**SUBJECT: DA 090/M005/18 Variation 1 – 248-252 Unley Road Hyde Park**

***Proposed Variation #1 Application***

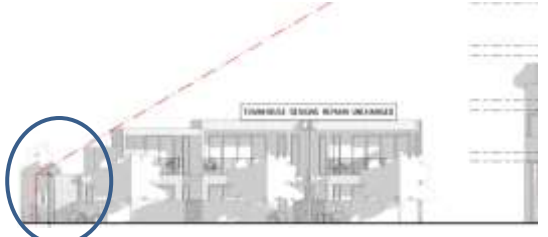
- a variety of other building, façade, balcony and minor and internal design revisions mostly of little consequence but reduced setback relief and harsh outcome with transformer on to Opey Street boundary and adjacent to main driveway opening.
